RN0074
Release Notes
CoreFIFO v3.0

- Updated changes related to CoreFIFO v3.0.
- Added [CoreFIFO v3.0 Migration](#), page 11.

Figure 1 • Expected SmartDesign view when migrating to CoreFIFO v3.0

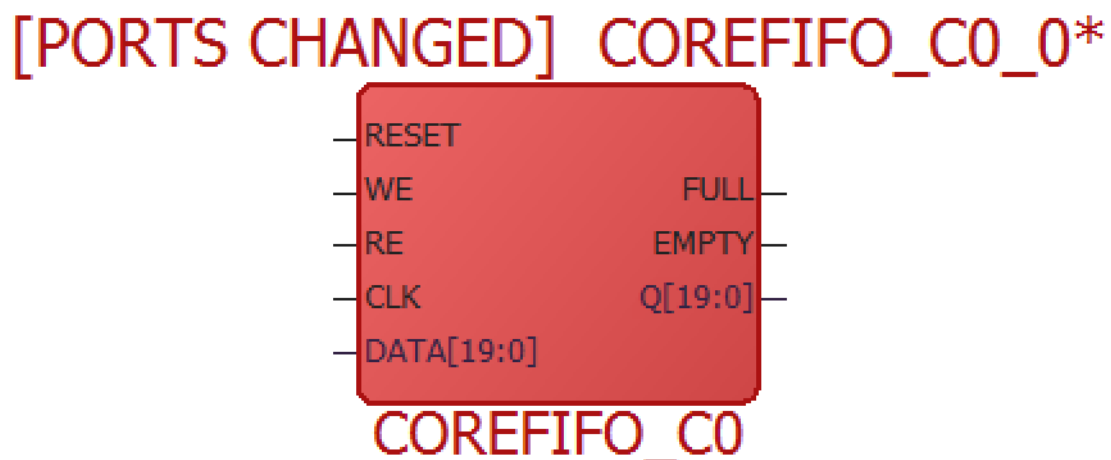
- When migrating to CoreFIFO v3.0 from earlier versions the user can expect following SmartDesign and logs windows.

Figure 3 • Log messages window when migrating to CoreFIFO v3.0

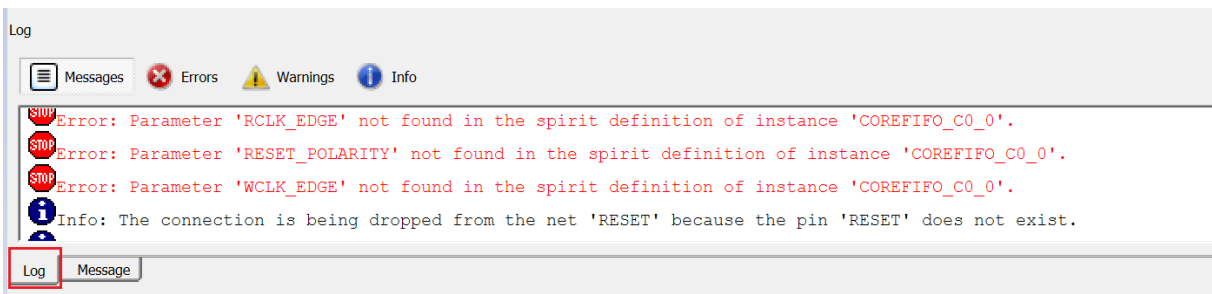
Note: User can safely ignore errors reported in the log window.

Figure 4 • SmartDesign configured for SYNC = 0

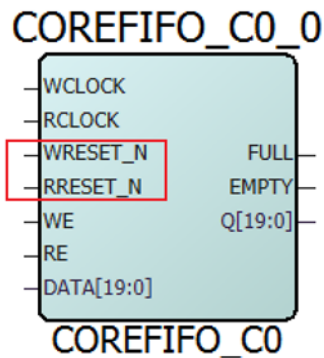
- When Clocks (SYNC) parameter is configured in dual clock mode (SYNC=0), two reset ports, WRESET_N and RRESET_N are exposed to the top-level ports.

- In the earlier version of the CoreFIFO, only one reset port (RESET) is used (for dual clock FIFO mode). This reset (RESET) input is synchronized internally with respect to the WCLK and RCLK domains.
- For CoreFIFO v3.0, two separate resets (WRESET_N and RRESET_N) ports (for dual clock FIFO mode) are exposed to the user. The user shall synchronize these two resets into the respective clock domain (WRESET_N in WCLK and RRESET_N in RCLK domain) **external** to the IP core.
- CoreFIFO v3.0 is not backward compatible for RESET port connection.
- User can refer to Figure 5 and Figure 6 for asynchronous and synchronous reset synchronizer respectively
